Luensmann Offsite Water Main Ext PH1
Solicitation Number: CO-00717
Job No.: 23-1043

ADDENDUM 1
11/16/2023

PLAT NO. _____
 JOB NO. 12473-09
 DATE MARCH 2023
 DESIGNER CD
 CHECKED MP DRAWN CD
 SHEET C3.05

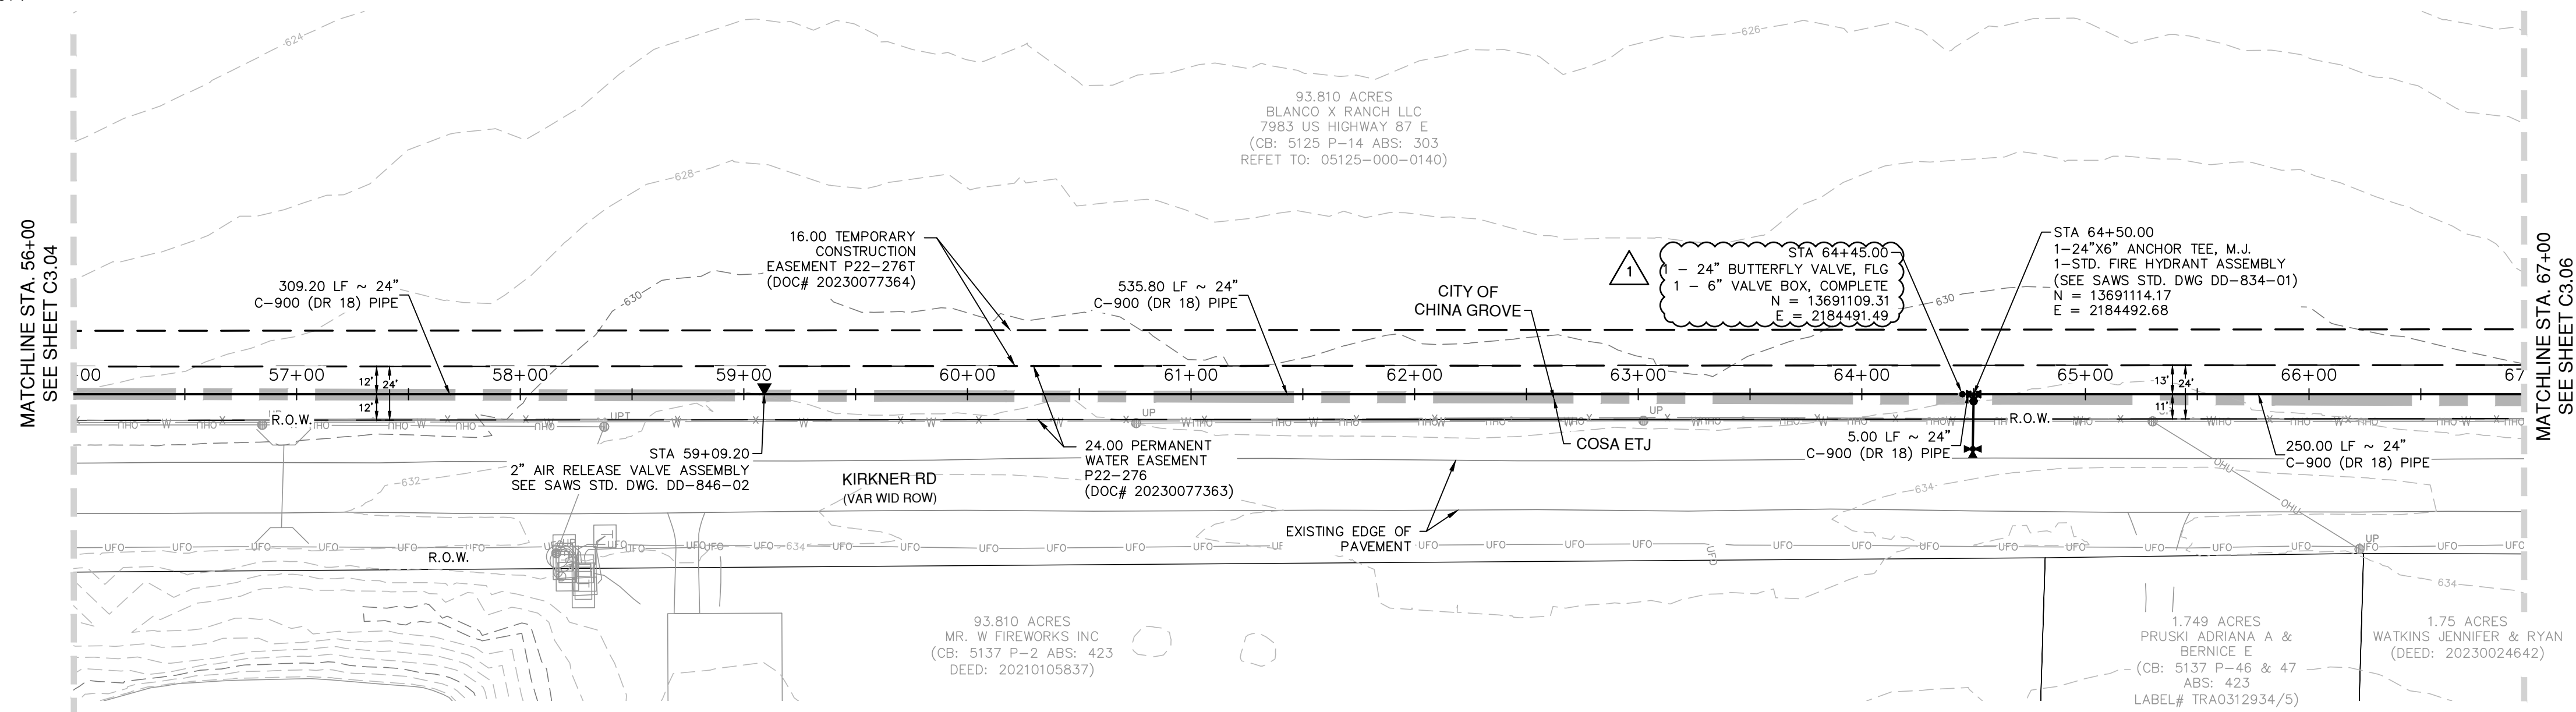
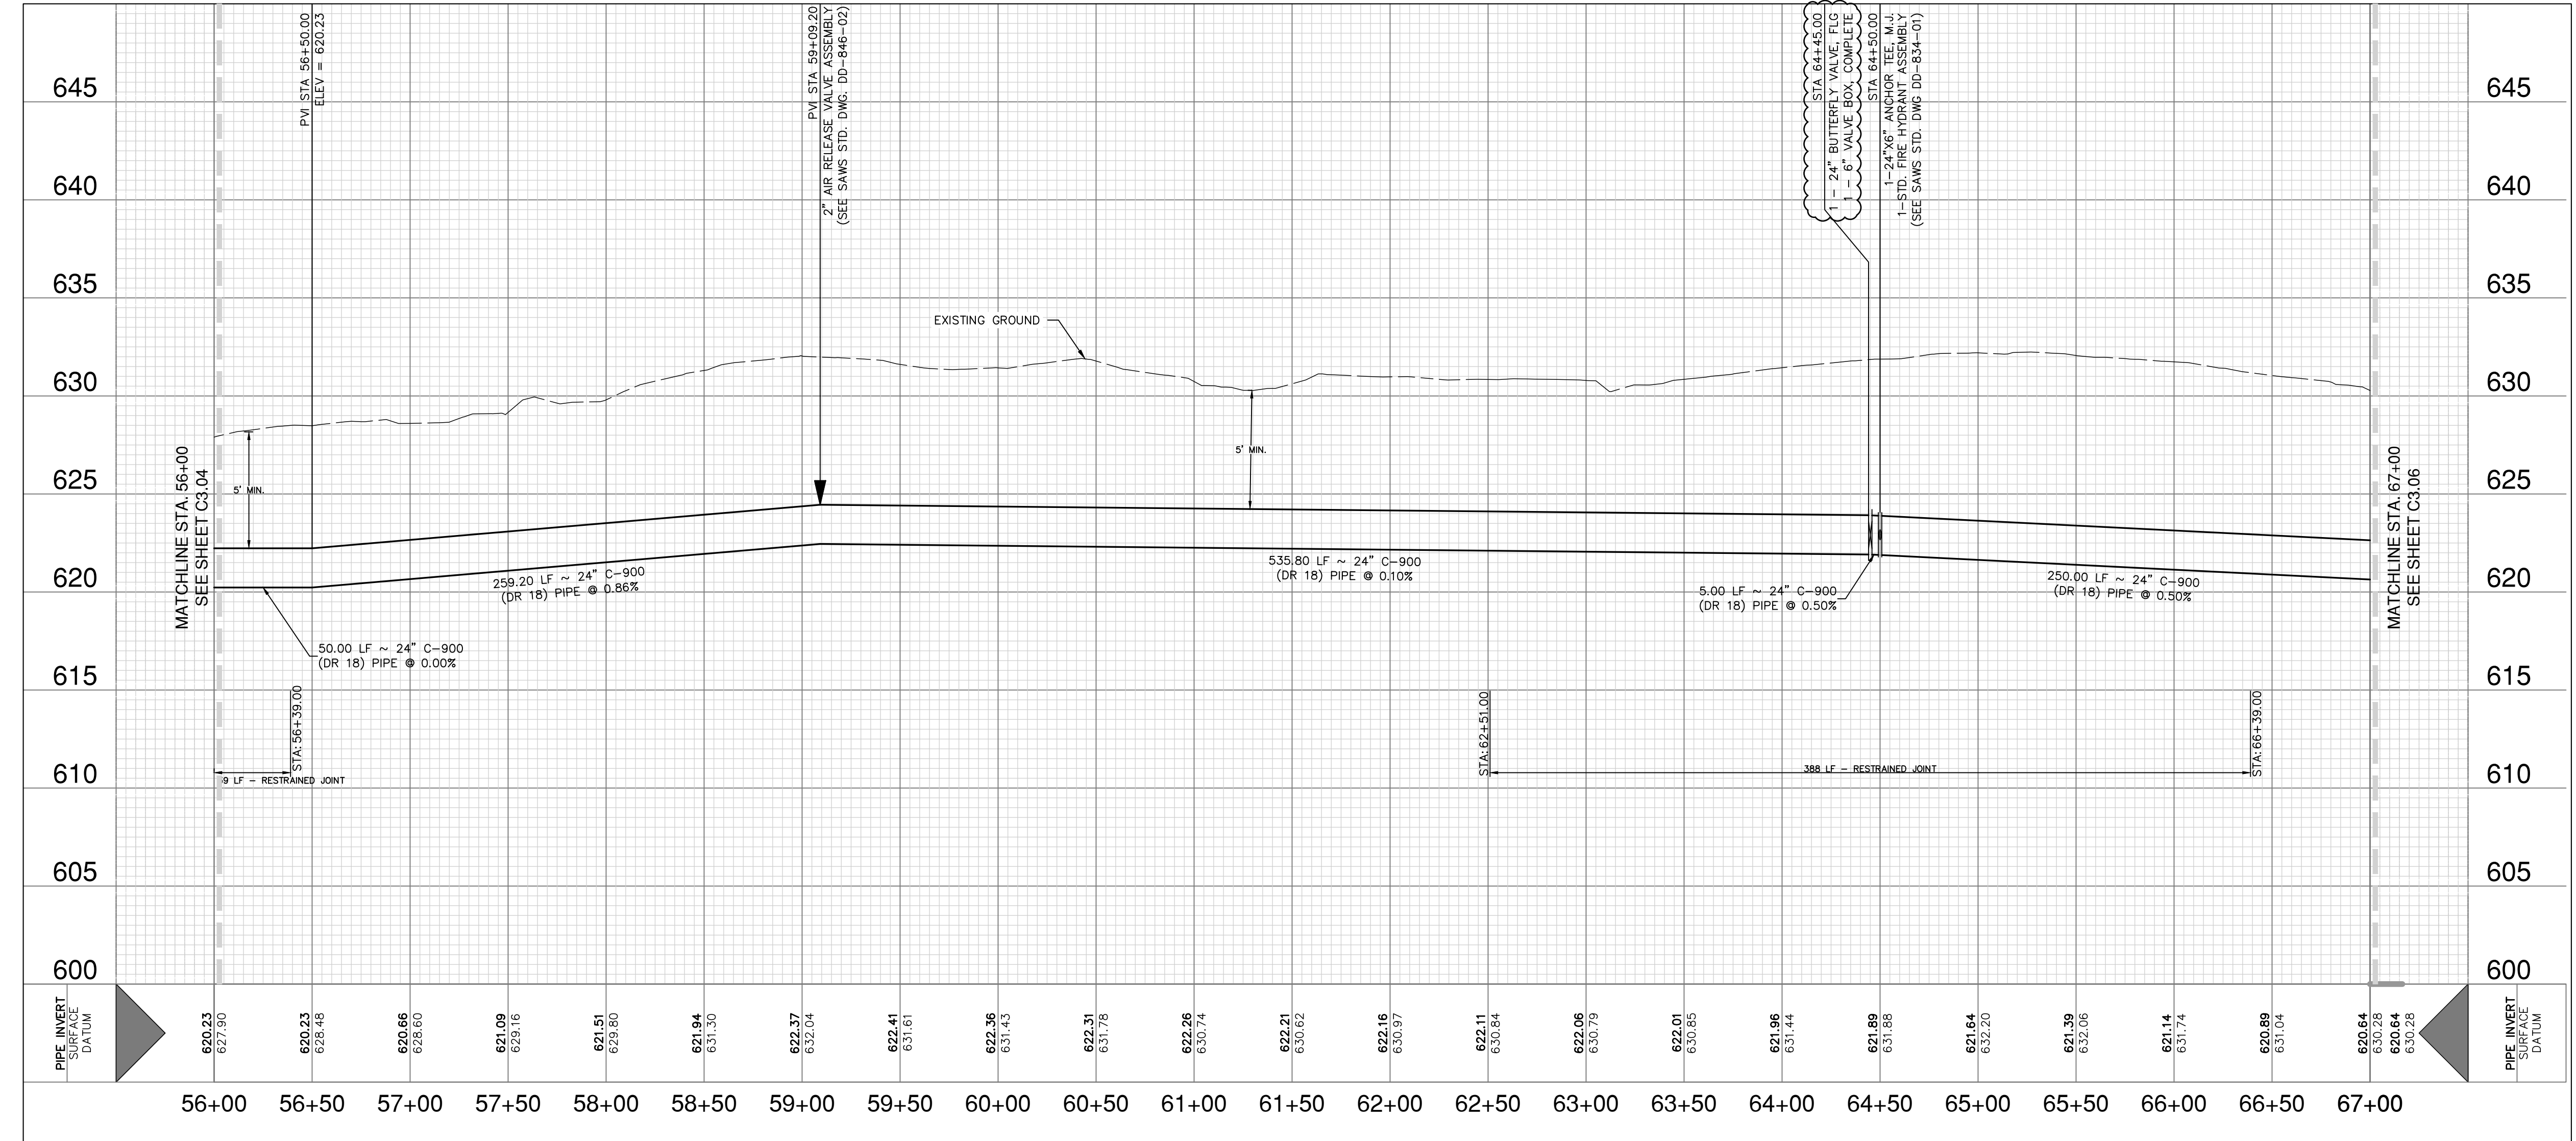
7. Sheet C3.05: Water Main Plan and Profile Sta 56+00 to 67+00 – Remove in its entirety and replace with the attached document.
 - Revised 24" Butterfly valve to be Flanged.

PLAT NO.
JOB NO. 12473-09
DATE MARCH 2023
DESIGNER CD
CHECKED MP DRAWN CD
SHEET C3.06

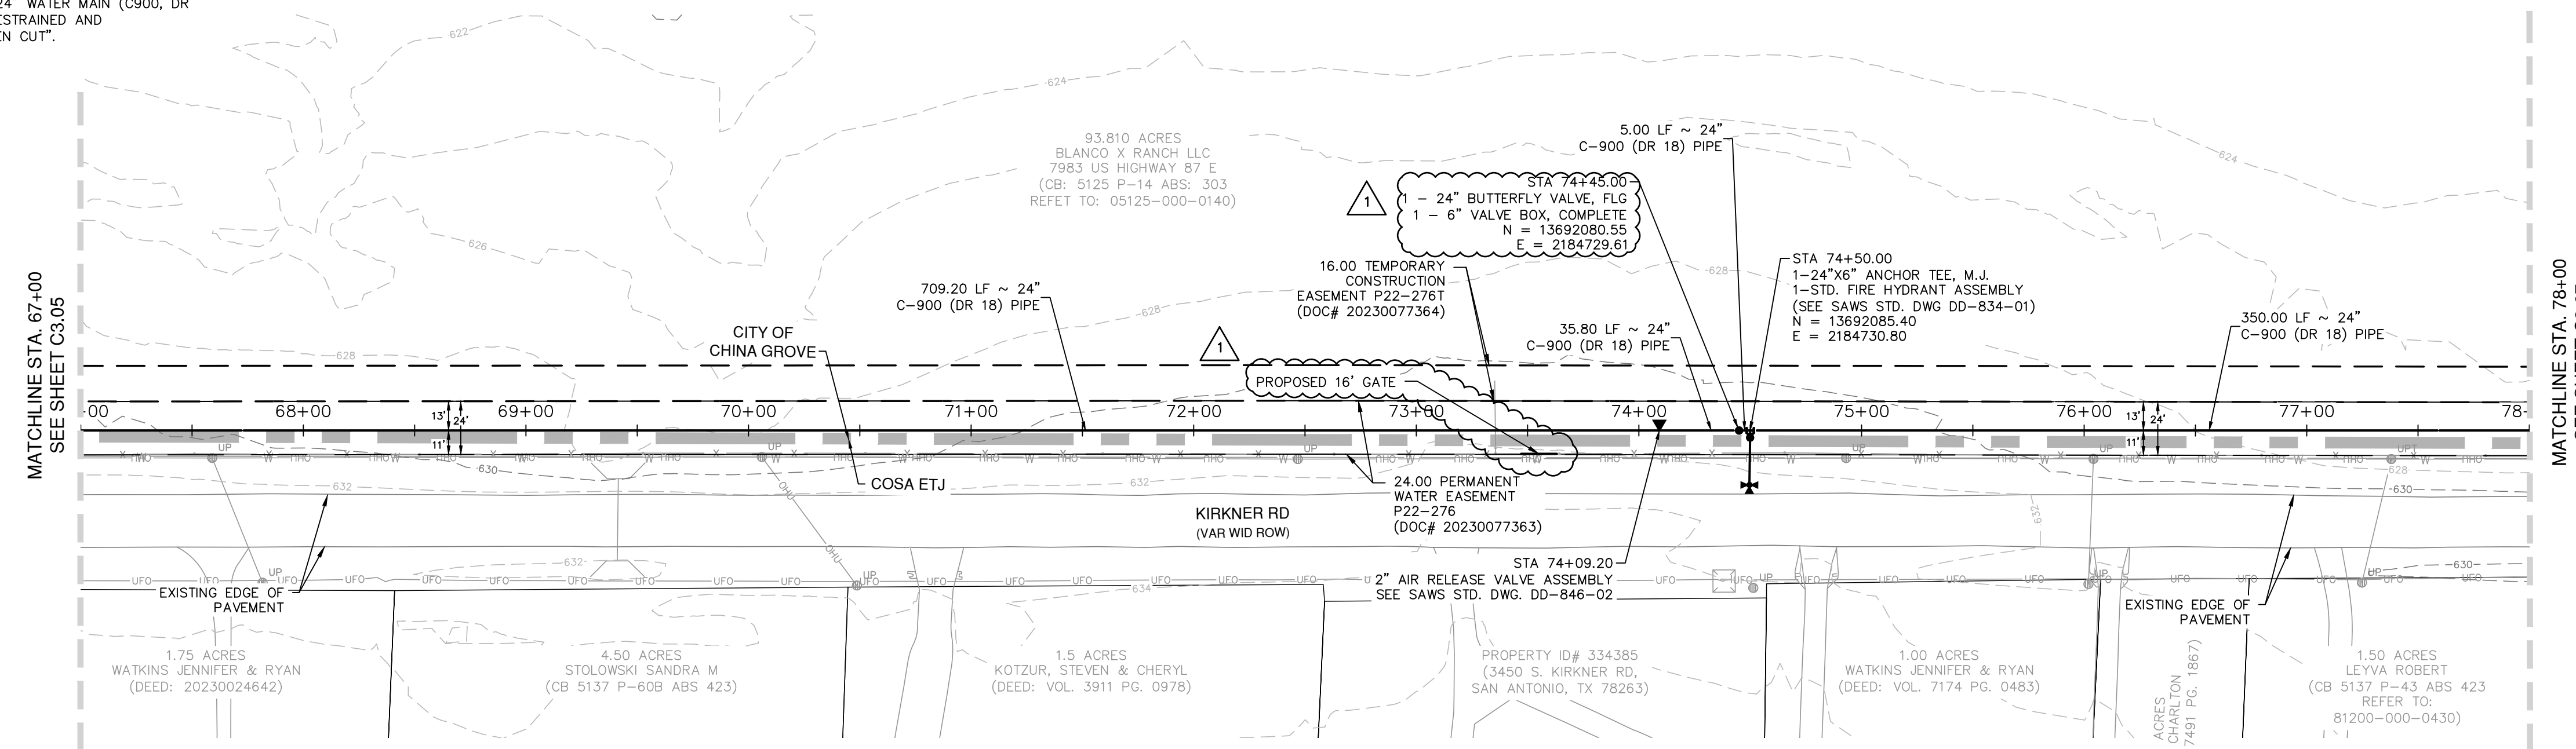
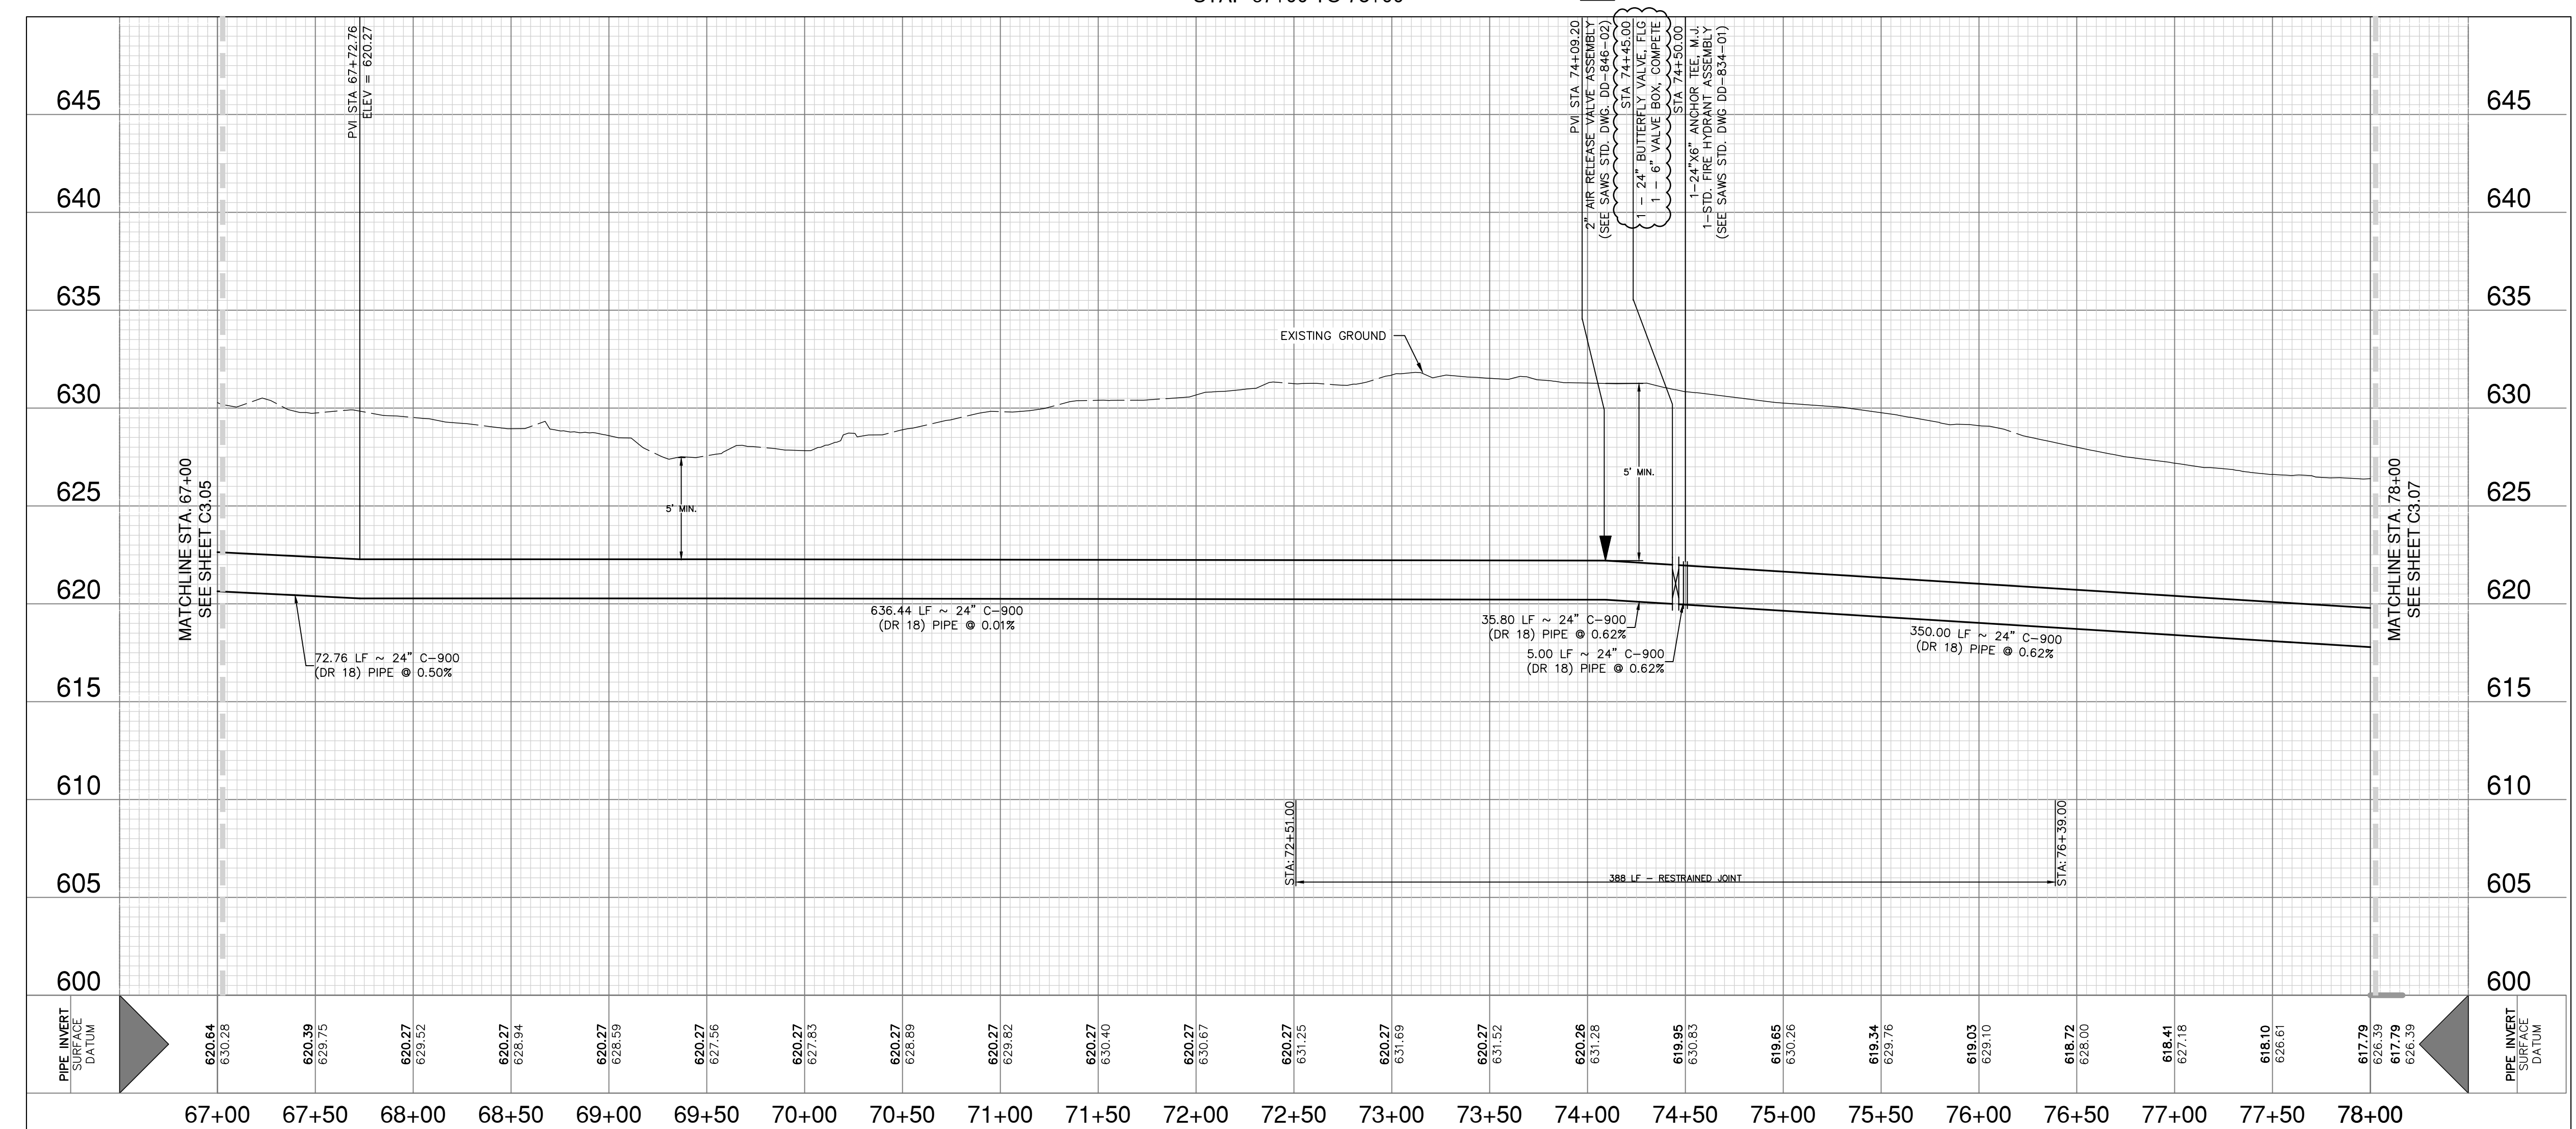
13. **Question:** What are the access points along Kirkner Road as there don't seem to be any gates?

8. Sheet C3.06: Water Main Plan and Profile Sta 67+00 to 78+00 – Remove in its entirety and replace with the attached document.
 - Updated quantity table to add a Fence Gate Type 1

Response: See Changes to the Plans #8. A gate has been added to sheet C3.06 to accommodate access from Kirkner Road.
